**ANALYSIS**  
of  
**ACCIDENT MARTINAIR DC-10-30F, MP495**

**FARO, 21 DEC. 1992**

**Limited supplemental analysis  
including comments on the investigation**

**Limited Supplemental Analysis Of The Accident With Martinair DC-10-30F, MP495**

Appendix 8. Graph 14 from the RvO, Annex 9. Aileron, bank angle and altitude

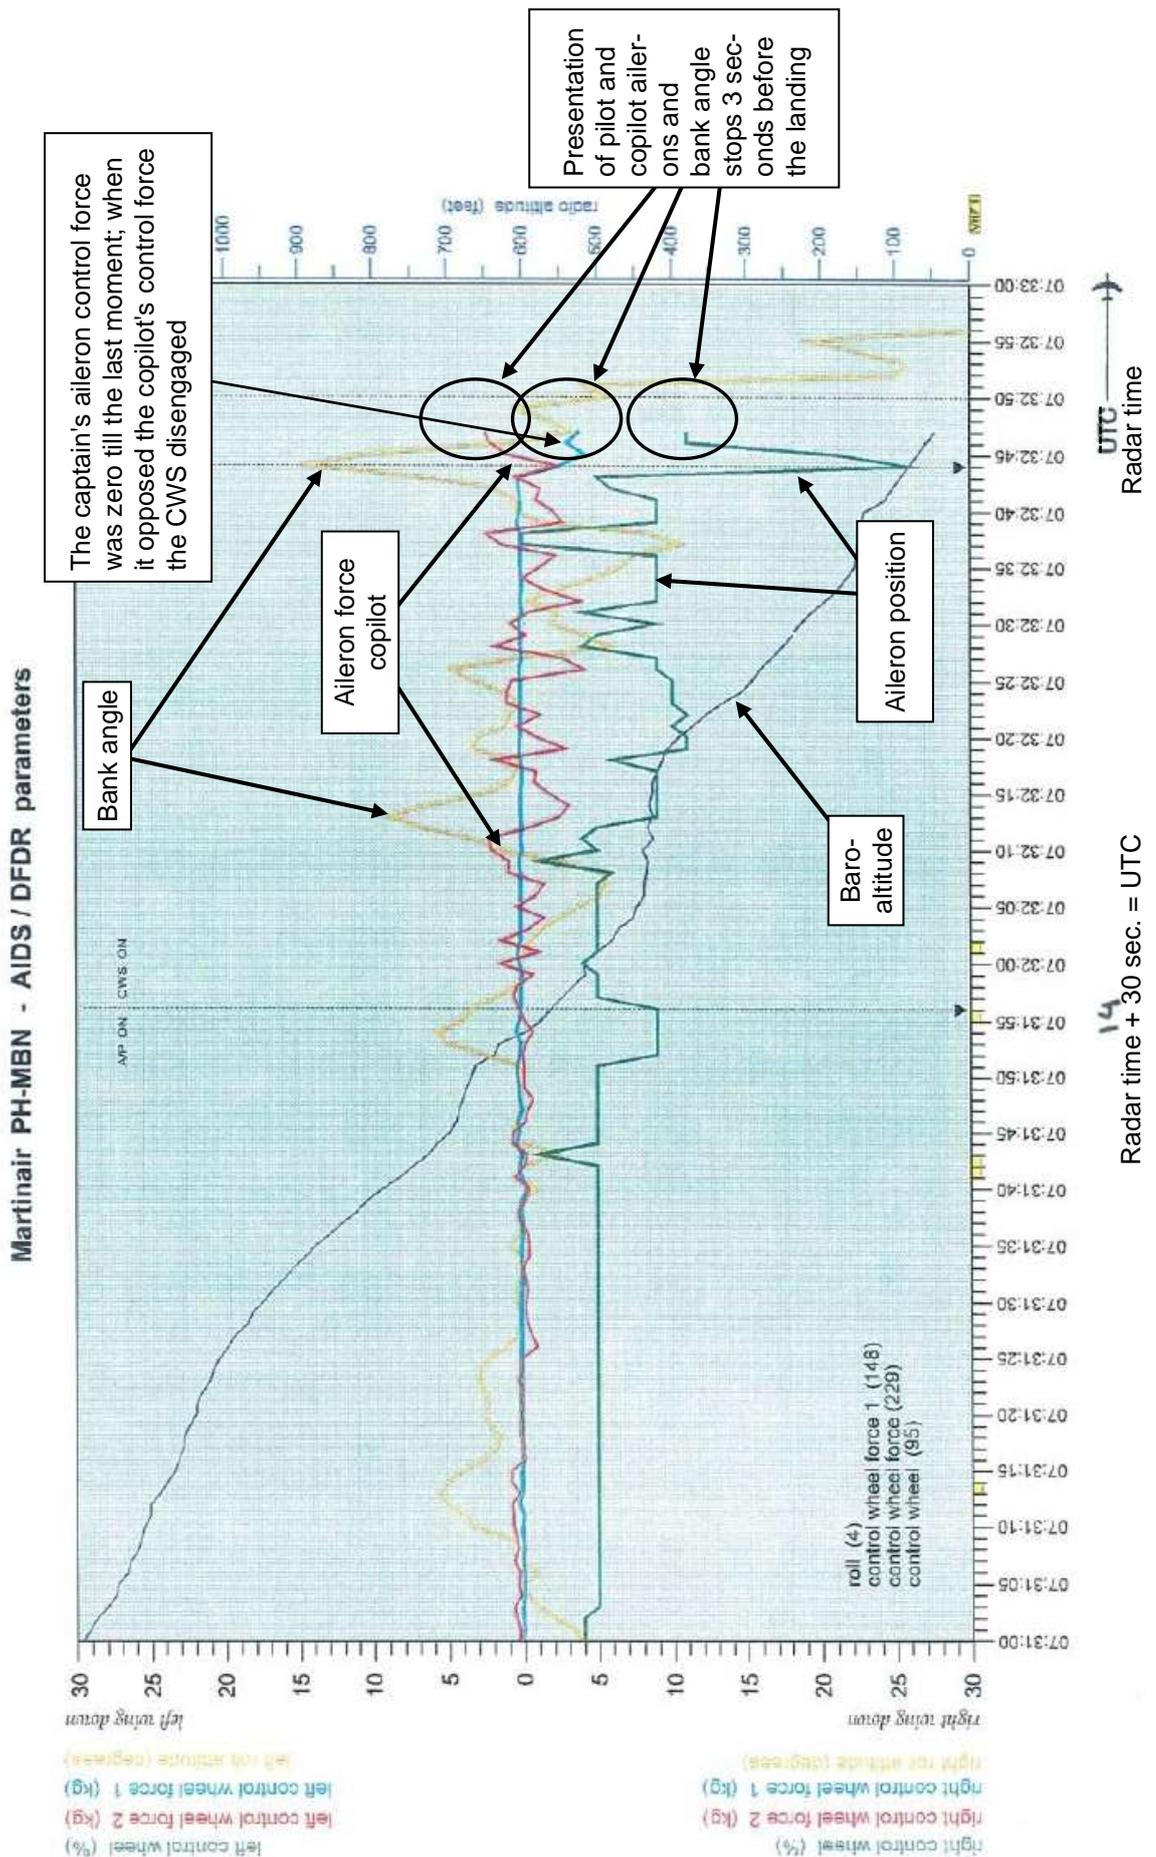
3.1.4. According to the RvO the movement around the longitudinal axis of the aircraft (the roll angle) indicated that the stability reduced, primarily from 07:33:20 UTC. That is quite correct, at that time the aircraft hit the ground and rolled around the longitudinal axis. (...) Presumably an earlier time is meant, as movement around the longitudinal axis during the last minute of the flight is shown in the graphs. However, this was fairly limited, apart from two peaks of 9° and 10° degrees. Nothing unusual given the crosswind at the time. According to the graphs there was hardly any counter aileron needed to correct the roll movements (Appendix 8).

Appendix 9. Graph 18 from the RvO, Annex 9. Speed, pitch, g, N1, descent rate

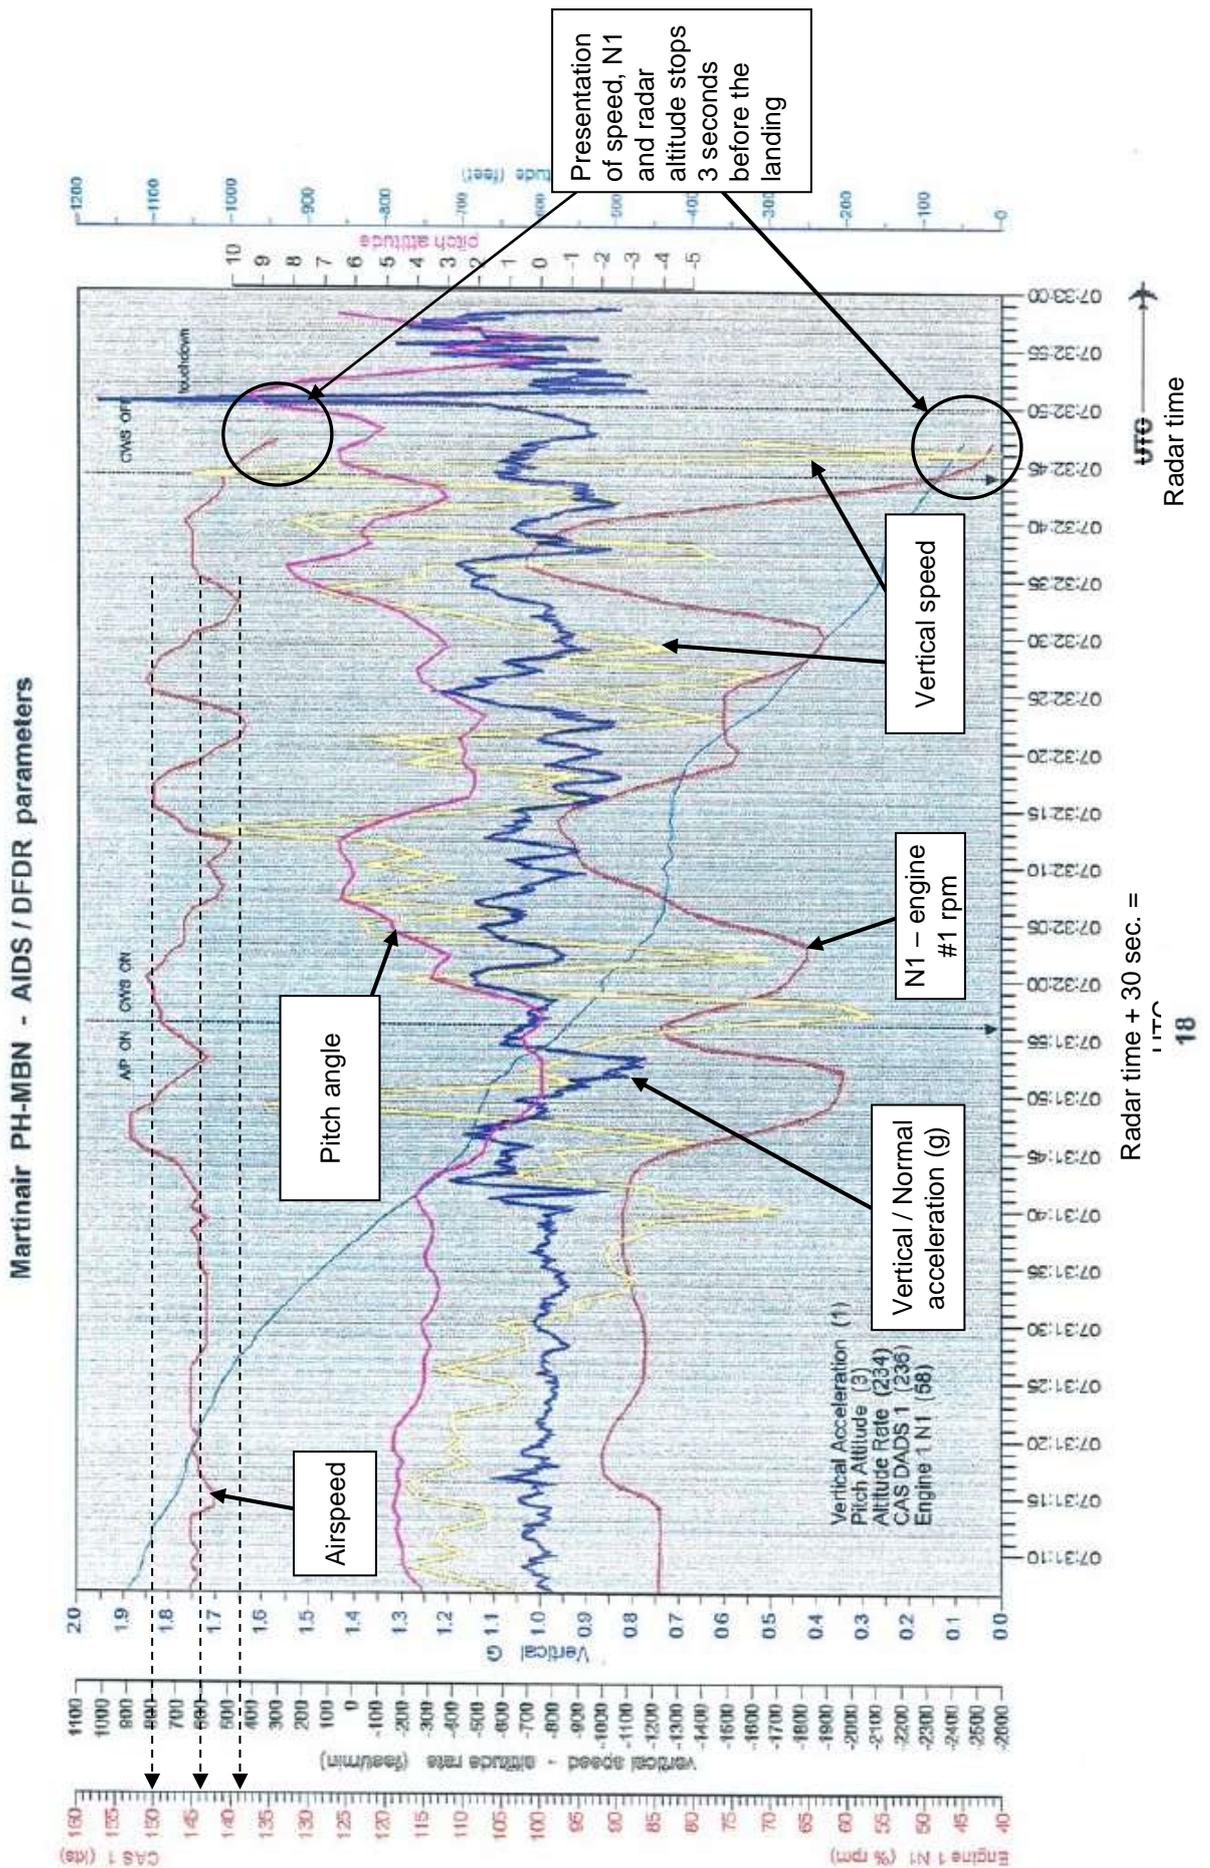
This vertical speed also stops, or was deleted, from three seconds before touchdown. The source of the vertical speed data is unclear, unrealistic and unreliable. Again, the full NTSB DFDR Factual Report could provide definite information. Hence RvO graph 18 should not be used to demonstrate
